SERVICE BULLETIN SB02.04

Machines/Models: X series With Entry Gate **Serial Numbers:** 1001 - 20116

PURPOSE: To simplify the operation and improve the safety of the Gate Latch Assembly

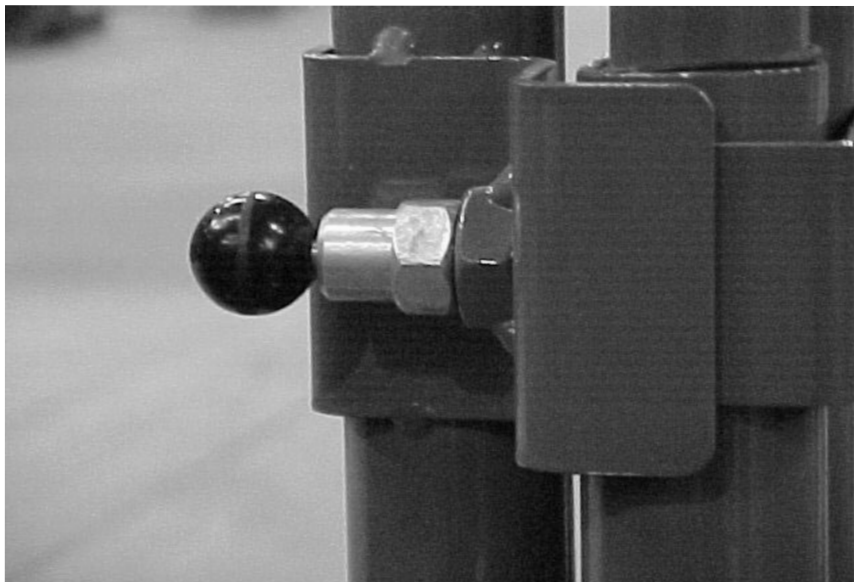
1. Remove and discard gate latch assembly.
2. Install new gate latch assembly part # 003570-005.

1. (1) Gate latch Assy part # 003570-005
